County of Fairfax, Virginia

STAFF REPORT

APPLICATION PRCA B-846

PROPOSAL: To construct a mixed use development of residential, office, and commercial uses across five buildings at a 2.80 Floor Area Ratio (FAR)

Figure 10: The proposed ingress from Reston Parkway, showing the ultimate road design with the third northbound lane on Reston Parkway in accordance with the Metrorail Record of Decision (Source: Urban, Ltd. – March 15, 2013)

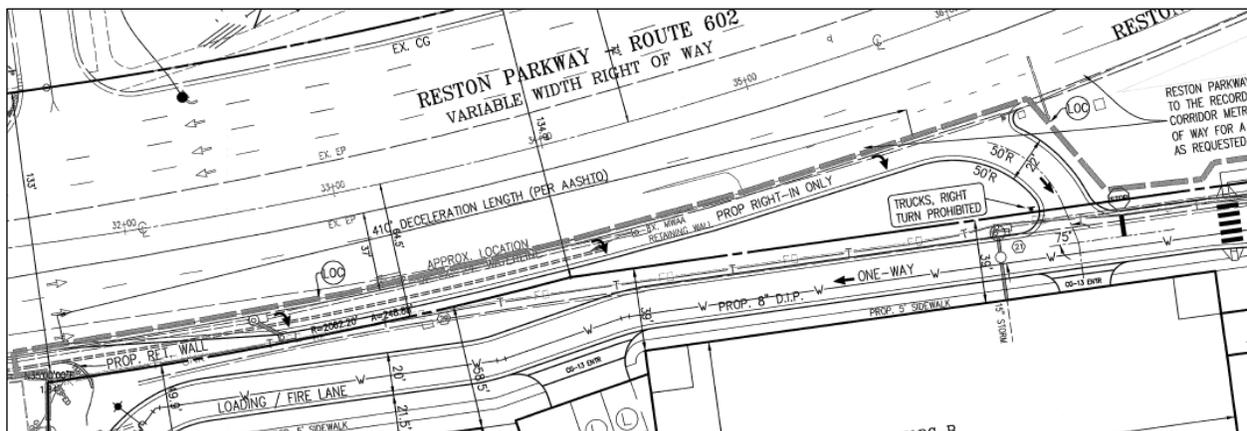
The applicant proposes a new access point on Reston Parkway (Figure 10) that would allow motorists to enter the site from the northbound travel lanes. The ingress would be located approximately 1,300 feet north of Reston Parkway’s intersection with Sunrise Valley Drive, and near the beginning of the roadway taper that widens out to become the eastbound ramp to access the Dulles Toll Road. The applicant would use an approximately 410-foot right turn lane to decelerate cars using this access point.

The applicant intends to construct this ingress in two stages. If site construction were to commence prior the construction of the ROD’s third northbound lane for Reston Parkway, the applicant would seek approval to construct an interim right turn lane in the general location of the northbound lane to serve the property’s ingress (Figure 11). In this scenario, the ingress would likely need to be closed temporarily to construct the third northbound lane. The applicant would then follow up the ROD with a new right turn lane for the ingress, displaying the ultimate condition shown in the PRCA Plan.

Figure 12: The stars indicate the proposed garage entrances (*Source: Urban, Ltd. – March 15, 2013*)

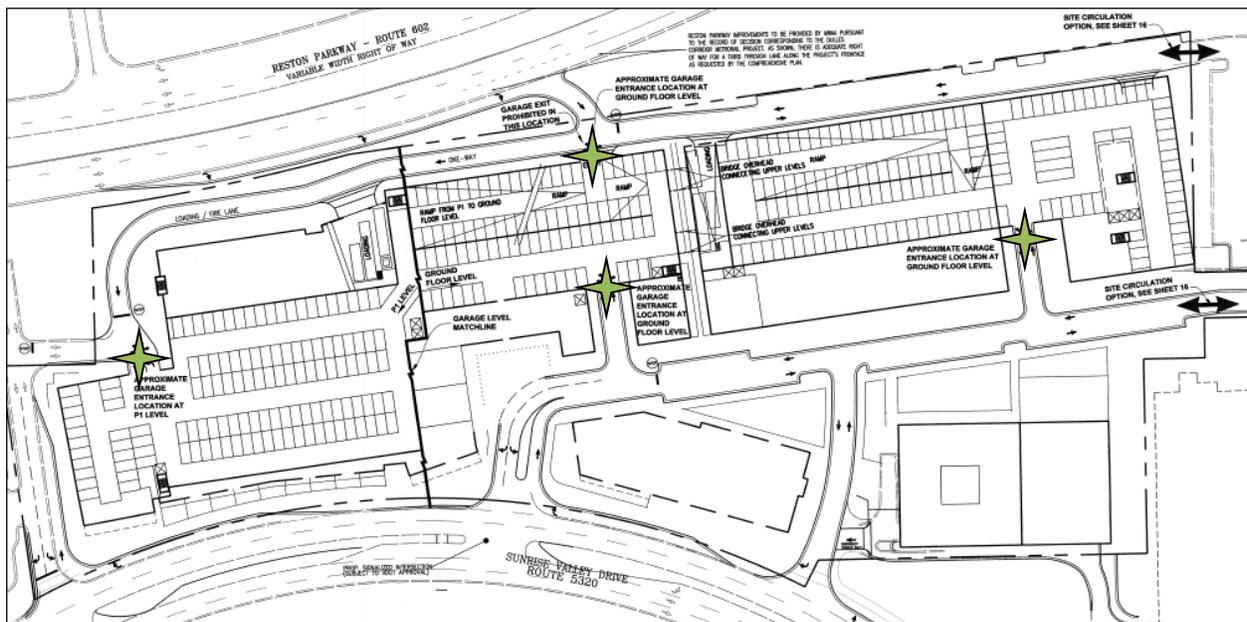
The parking garage levels would be interconnected, allowing motorists to enter one entrance, travel through the garage, and exit through another entrance. The garage would have four entrances (Figure 12). One entrance would serve cars entering the site from Reston Parkway, while a second entrance would be located at the southern end of the site. The remaining two entrances are located along the retail plaza's drive aisle. The Reston Parkway entrance would allow cars to enter but not exit the garage, while the three other entrances would allow entry and exit.

Figure 16: These images show how the modular cells can be used under pavement surfaces to increase soil volume for trees (Source: Olin Partnership, Ltd. – March 15, 2013)

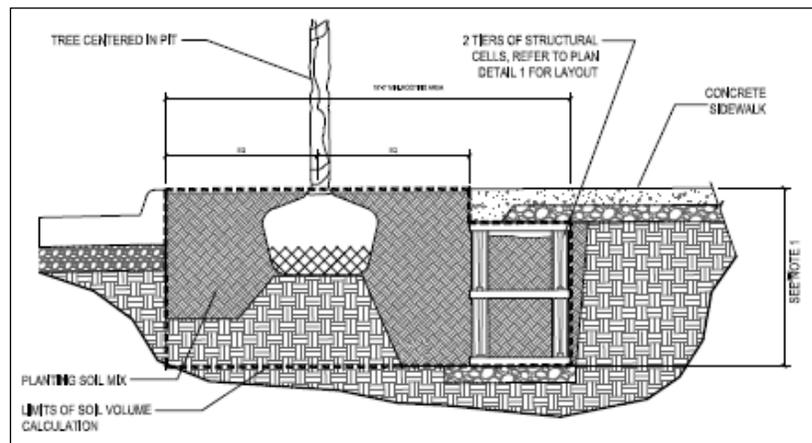
The PFM requires an eight-foot wide rooting area for trees. To reduce this required width but still maintain the necessary soil volume for healthy tree growth, the applicant would use modular suspended pavement cells for planting trees in selected areas (Figure 16). These cells are filled with soil and located under the sidewalk adjacent to where a tree is planted, allowing tree roots to extend underneath an improved surface without compromising the integrity of the surface. Structural cells are permitted in the PFM as an alternative method for planting trees in an urban context. The applicant also indicates that structural soils, which would replace conventional soil with a stone aggregate, could be used in some locations. Staff is opposed to the use of structural soils in lieu of using conventional soils to satisfy the PFM’s minimum soil volume requirements.

Figure 17: The dark line shows a conceptual location for the RMAG sidewalk (Source: Urban, Ltd.)

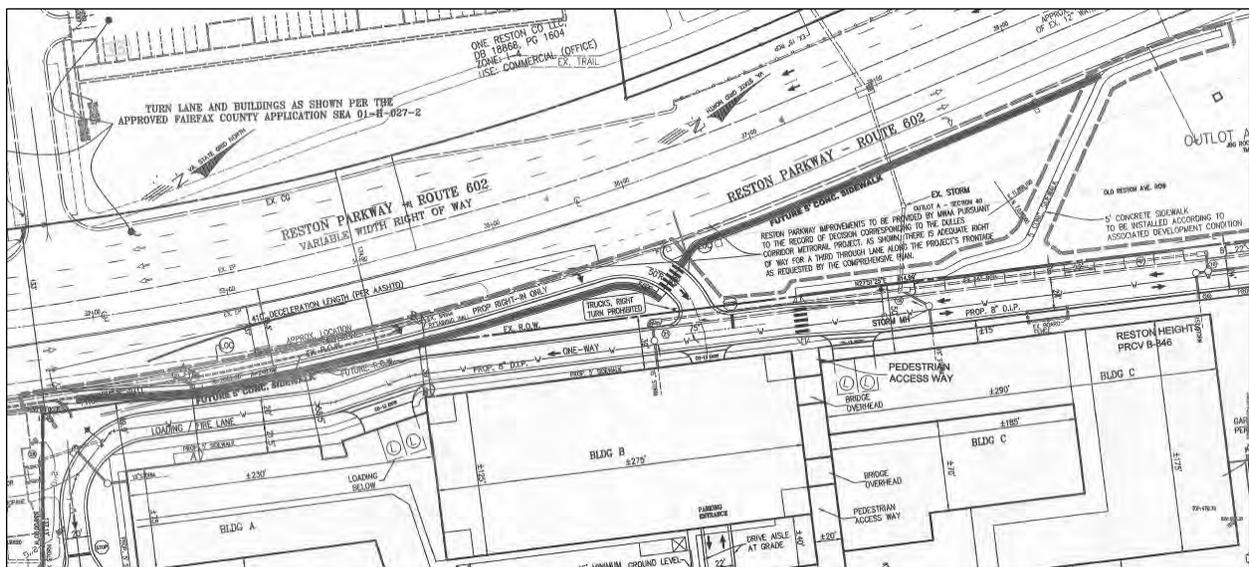
To address this concern, the applicant has agreed to construct a five-foot wide sidewalk along the property’s Reston Parkway frontage. This ensures that the applicant would bear any additional costs beyond those projected by RMAG. The applicant would need to construct the sidewalk to accommodate the ROD and the right turn lane into the site. Staff is supportive of this resolution.
